From: Mark Hecker
Sent: Monday, August 13, 2007 4:25 PM
To: David Woosley
Cc: Charles Soules; Shoeb Uddin; John Gress
Subject: RE: DeVictor Park

Figure 4. Pedestrian crash rate vs. type of crossing.

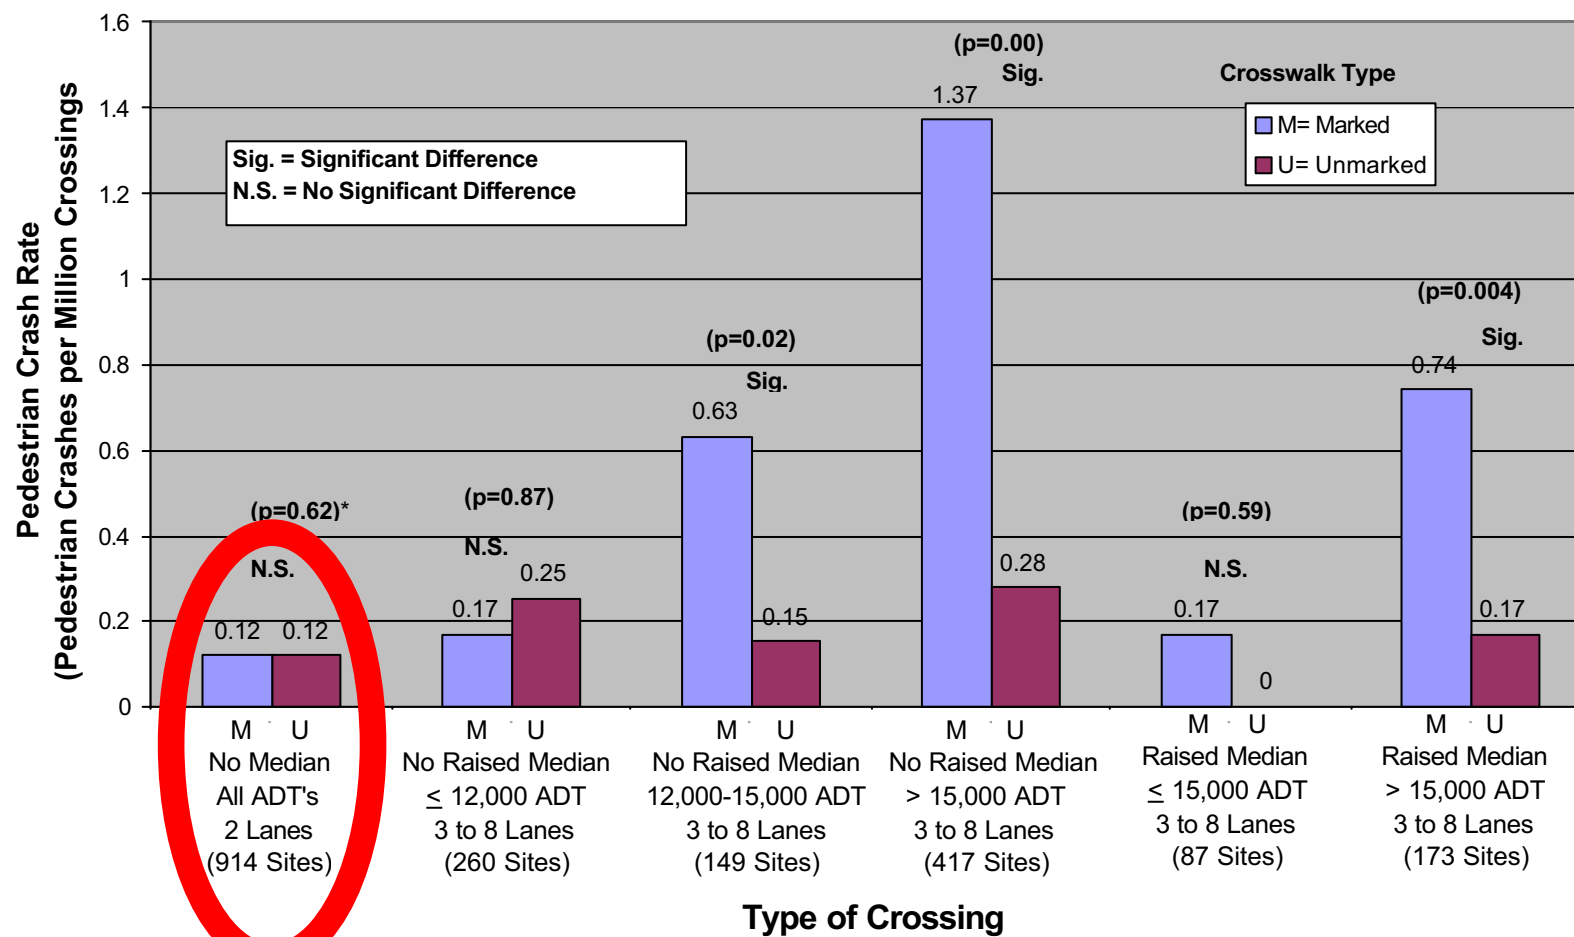
The attached "DeVictor Crossings" map shows the locations that trail traffic is currently crossing Harvard (red X). We feel that ramps and a marked pedestrian crossing need to be installed in these locations for safe trail use and to warn ongoing traffic. Currently trail users are jumping the curbs to cross at these locations.

We understand the issues associated with mid-block crossing and do not anticipate encouraging pedestrian traffic crossings on George Williams Way or Bob Billings Parkway. However, we have little choice on Harvard if we want to access the entire park. It would seem that with the traffic circle and round-a-bouts already in place on Harvard that traffic may be slowed enough to allow for safe crossings at these trail intersection.
